ADDENDUM NO. 3**Fire Alarm Retrofit Project, CIP No. 23457**

3.01 Refer to the Request for Proposal, Scope of Services:

3.03 Add to the RFP Attachment 1 – Maps:

**LIBRARY BACKFLOW
CIP 23457, FIRE ALARM RETROFIT
RFP, ATTACHMENT 1 - MAPS**

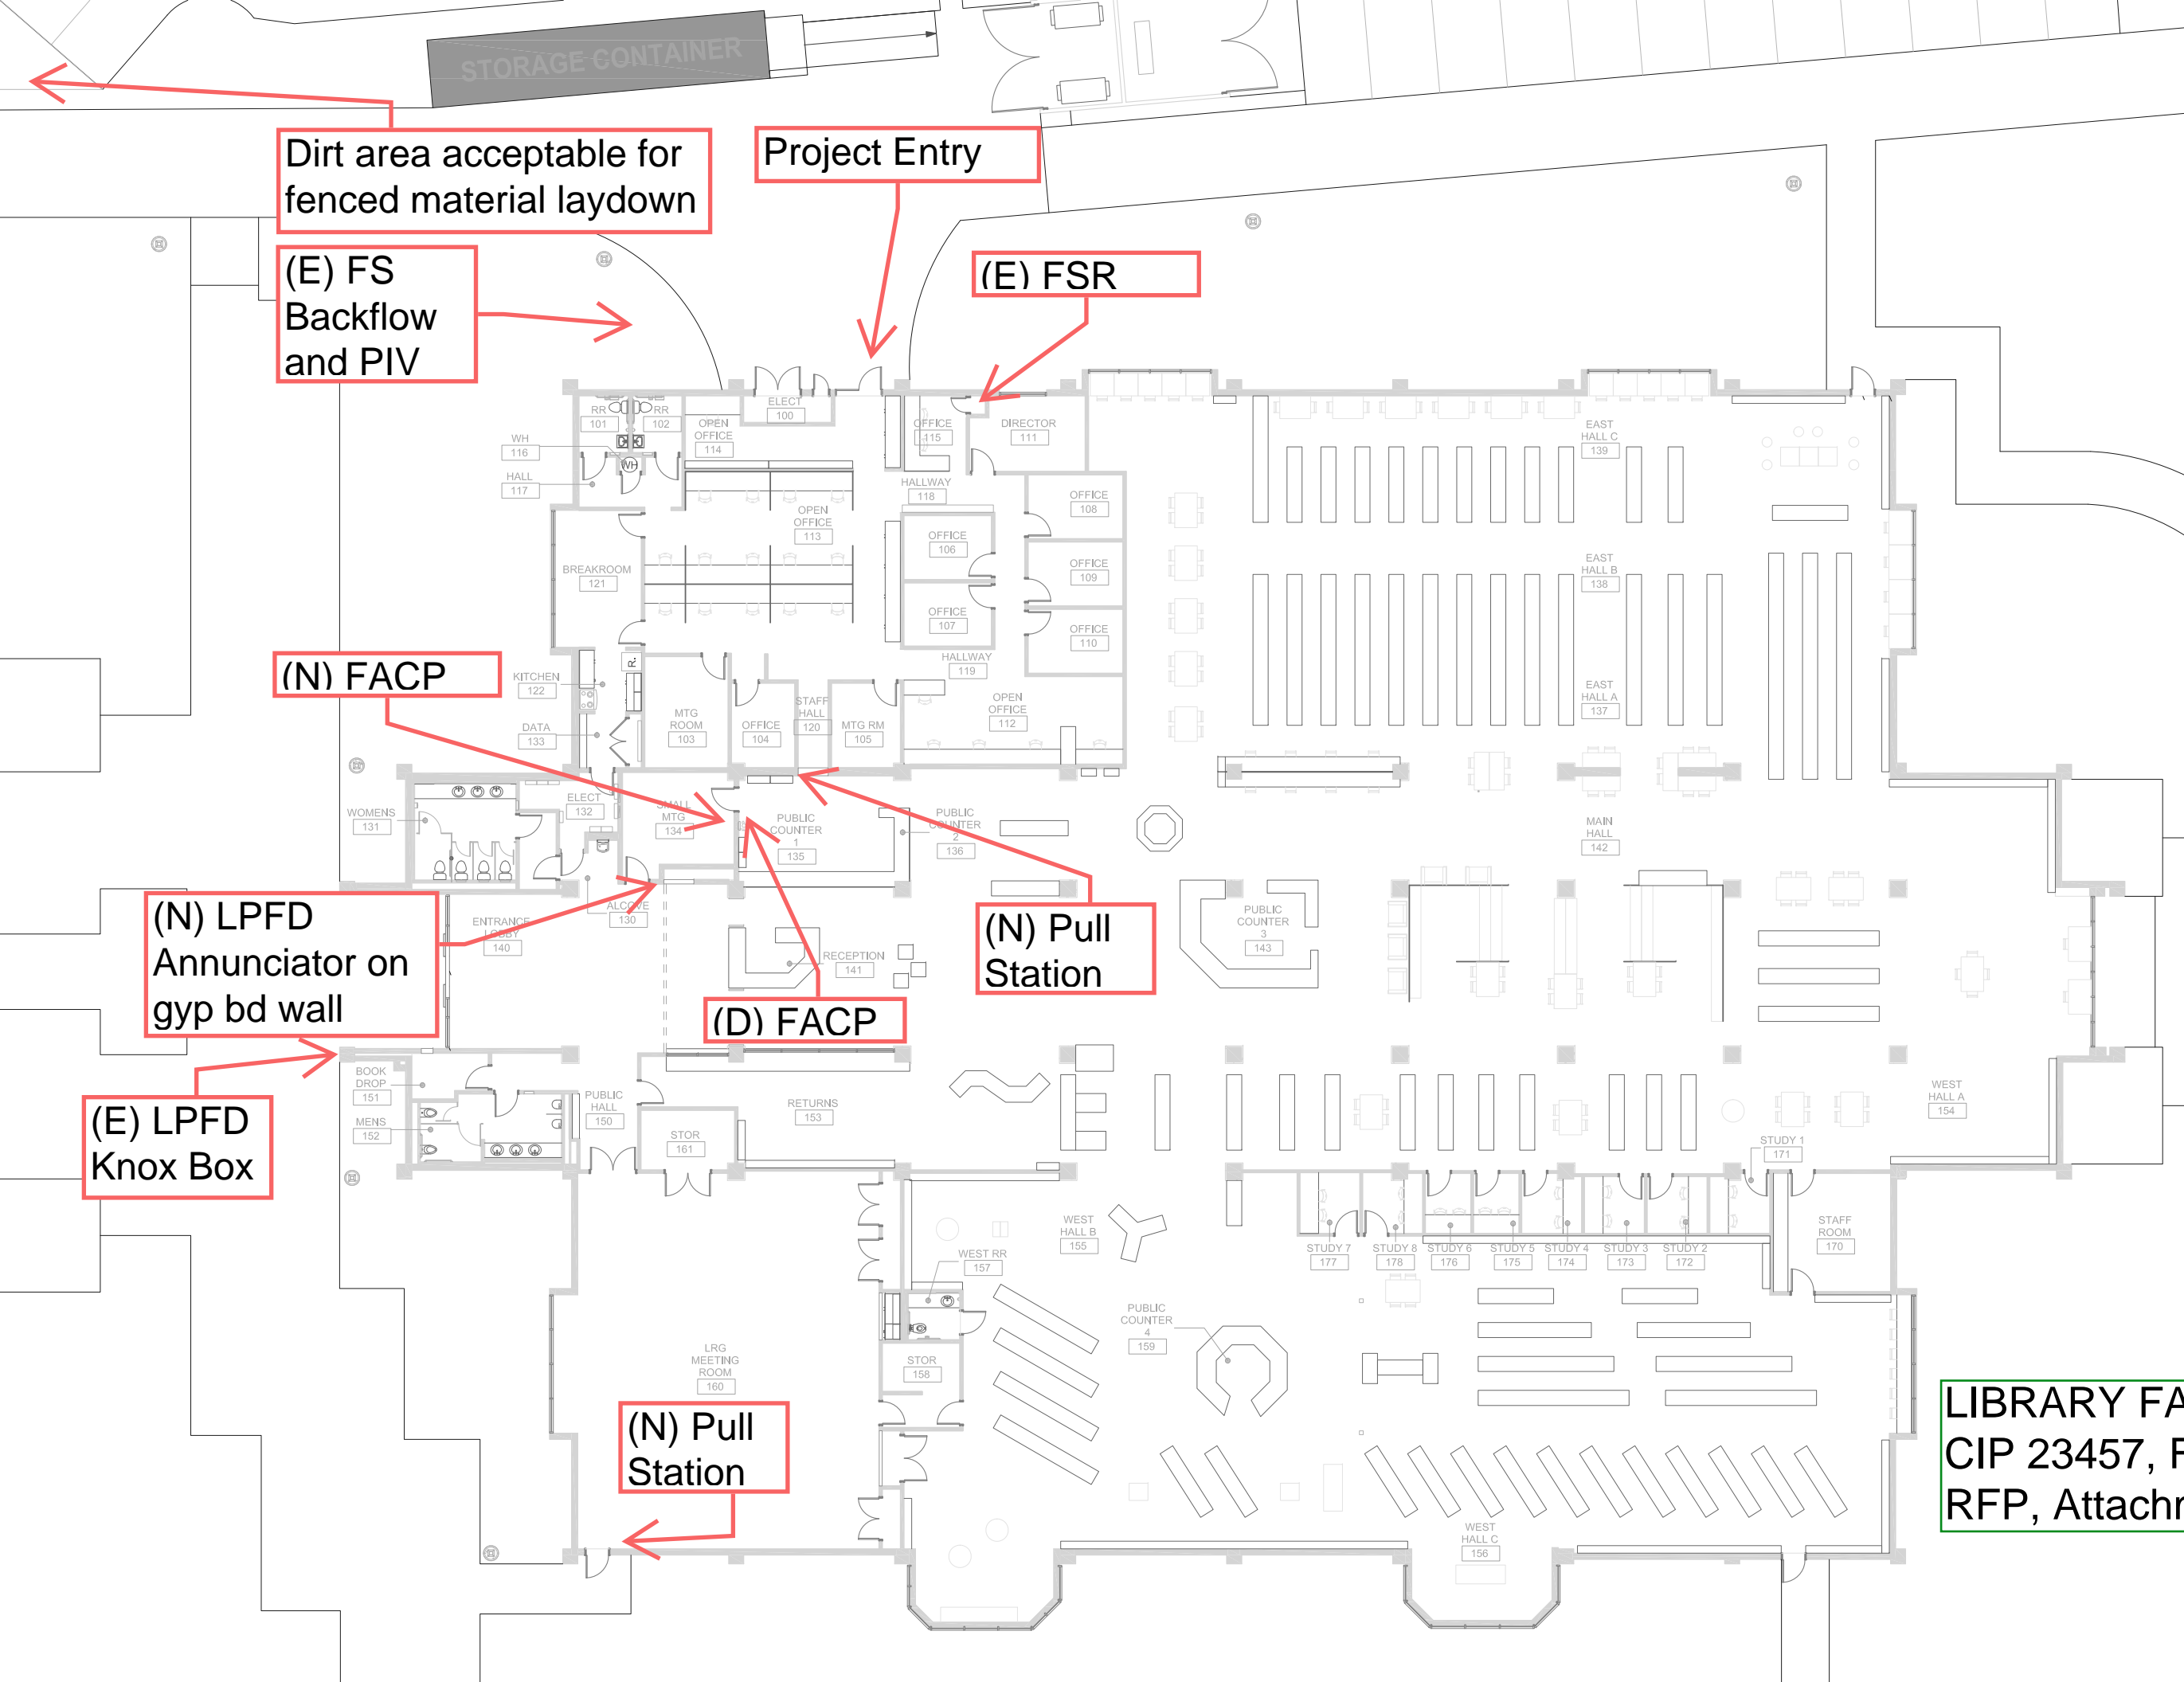
Library Backflow: A suggested diagrammatic piping plan and section view for the new above grade backflow incorporating City Standard Detail 705 to replace the underground backflow with the relocated PIV added inside the existing vault. Existing underground piping is not verified in the suggested drawing or the reference drawing copy 'Library C3 Utilities 1987'. The requirements of RFP Scope of Services, Bid Items No.1 and No. 4 are not changed. The proposal shall include investigation to verify existing below grade conditions and provide a design that meets code and permit requirements.

LIBRARY FACP
CIP 23457, Fire Alarm Retrofit
RFP, Attachment 1 - Maps

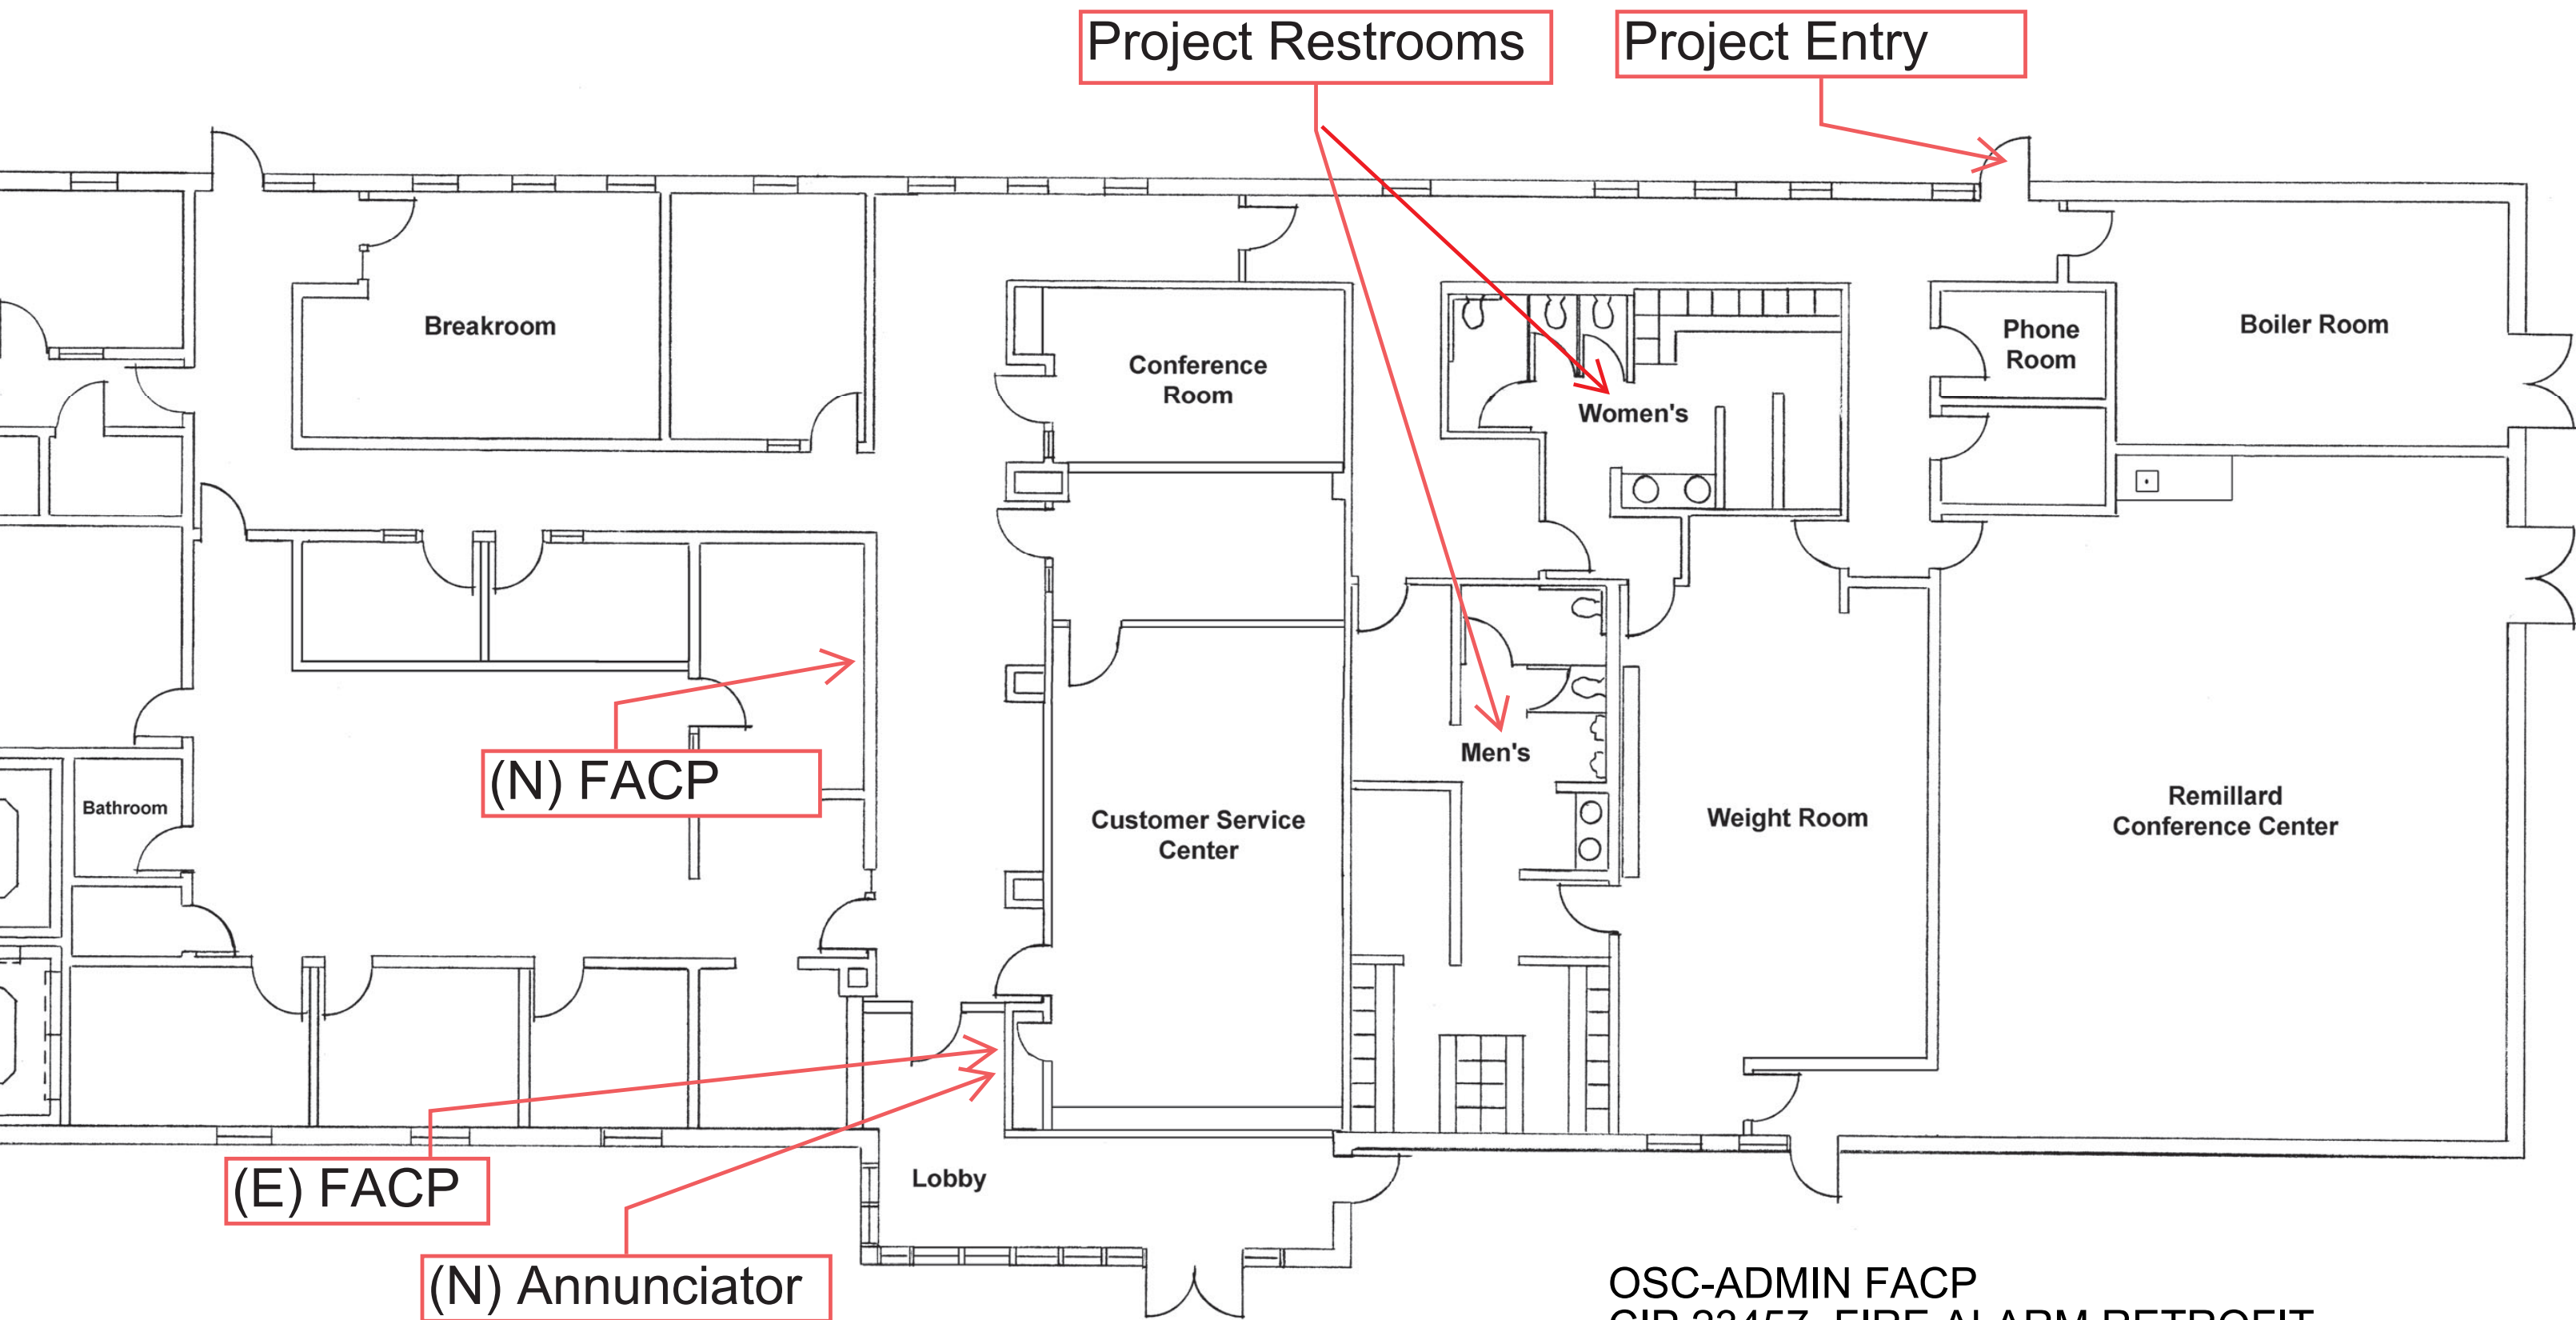
Library FACP: A floor plan showing the demolished and new FACP and the new annunciator. The pull station under the existing FACP shall be demolished and a new pull station provided at the location noted. An additional pull station shall be provided in the

Large Meeting Room noted. The proposal shall include investigation to verify existing conditions and provide a design that meets code and permit requirements. An additional location for a fenced fire sprinkler material laydown is shown on the plan. The specific requirements identified in Attachment 2 – Special Provisions, Bid Item No. 3, for the Library shall remain unchanged.
